**1958 Agreement – Consideration of draft amendments  
to existing Regulations submitted by GRSP**

### **Proposal for Supplement 1 to the 03 series of amendments to Regulation No. 29 (Cabs of commercial vehicles)**

#### **Submitted by the Working Party on Passive Safety \***

Annex 3, Appendix 2,

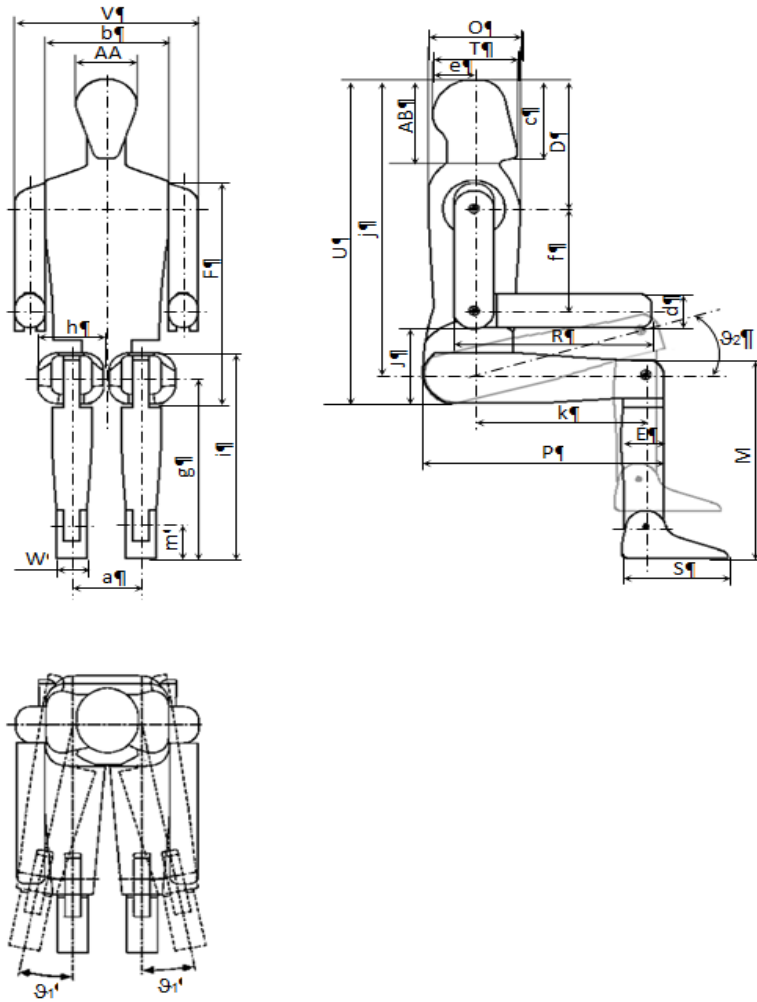
The figure, amend to read:

The table, amend to read:

<i>Dimensions</i>		
<i>Name</i>	<i>Description</i>	<i>Dimension, in mm</i>
AA	Breadth of head	153
...	...	...
$\theta_1$	Lateral rotation of the legs	20°
$\theta_2$	Upward rotation of the legs	45°
